***APPLICATION NUMBER:***  
**BLA 125057/S-381**

***Trade Name:*** HUMIRA

This "Prior Approval" supplemental biologics application provides for a modification to the firing button component for the Humira Pen.

**Medical Officer Review**

**Figure 1: Currently Approved Humira Pen**

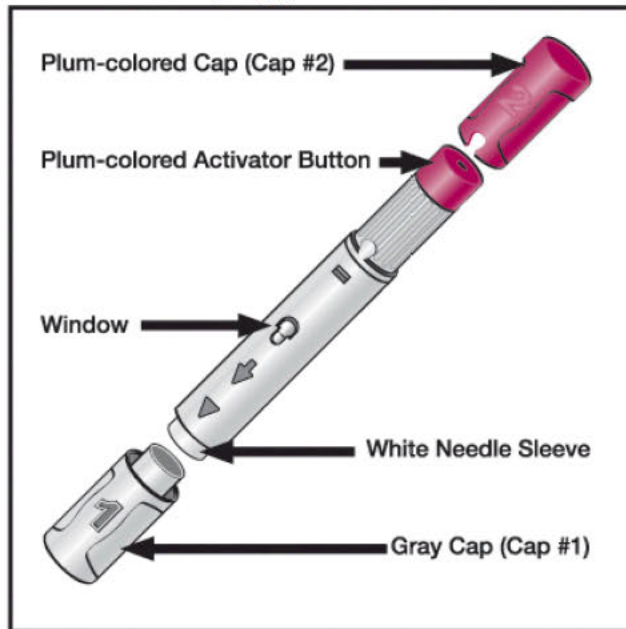
The currently approved Humira Pen is shown in Figure 1. In order to inject Humira, patients must first remove the gray cap (Cap 1) to expose the needle. Next, the plum-colored cap (Cap 2) is removed to expose the plum-colored activator button.
